Contract #: 04-0120F4Cty: SF/ALA Rte: 80 PM: 13.2/13.9File #: 69.25B

QUALITY ASSURANCE -- NON-CONFORMANCE REPORT

Reference Description: Critical Weld Repair Performed without Engineer's Approval, Segment 5BE**Description of Non-Conformance:**

Job Name: SAS Superstructure
Document No: 05.03.06-000554

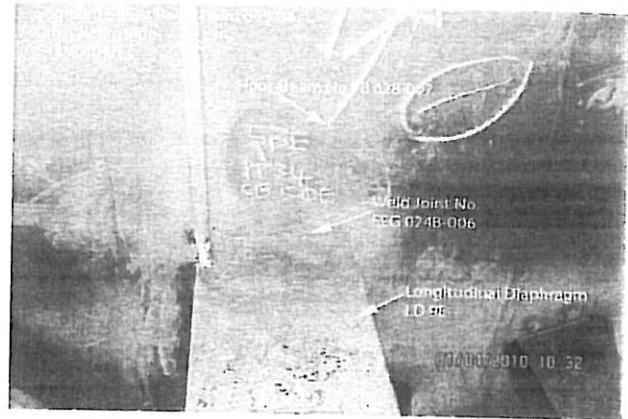
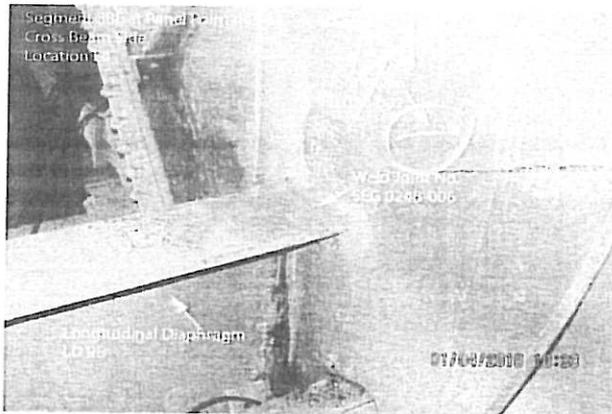
-A critical weld repair being performed without the Engineers approval.

-The weld is a Complete Joint Penetration (CJP) T-joint identified as SEG024B-006 @ Panel Point 034.

-The weld is designated as Seismic Performance Critical Material (SPCM).

-The weld is joining longitudinal diaphragm, LD 9E, top flange identified as X44AE to floor beam, FB028-002, web identified as X94H (SPCM).

The repair is considered a Critical Weld Repair (CWR) for the following reasons:

-The weld thickness is 25mm.

-The weld was excavated to a depth of approximately 25mm.

-The maximum depth of a non-critical weld repair shall not exceed 65% of the weld thickness.
